9 July 2017

**RE: ENGINEER ASSESSMENT OF FAILED RETAINING WALL
PEDESTRIAN WALL ON SOUTH SIDE OF WALKWAY
TREE DAMAGE TO WALL
15 EAST ESPLANADE MANLY
FOR SP 6749**

The engaged pier whereby roots are visible at the construction joint

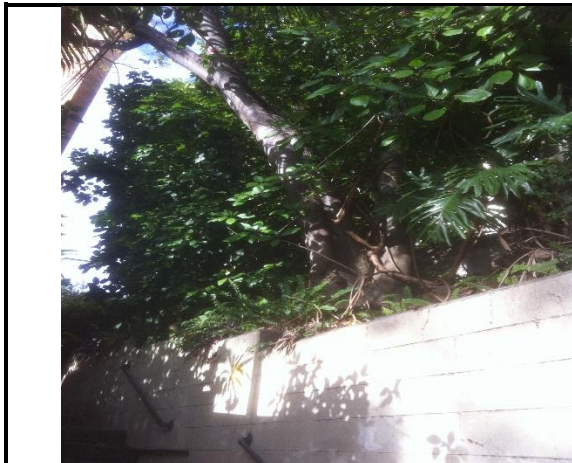
The subject tree roots are visible from the opened joints in the wall adjacent to a an engaged pier located on the corner of the wall. The tree roots are visible directly up against the wall.
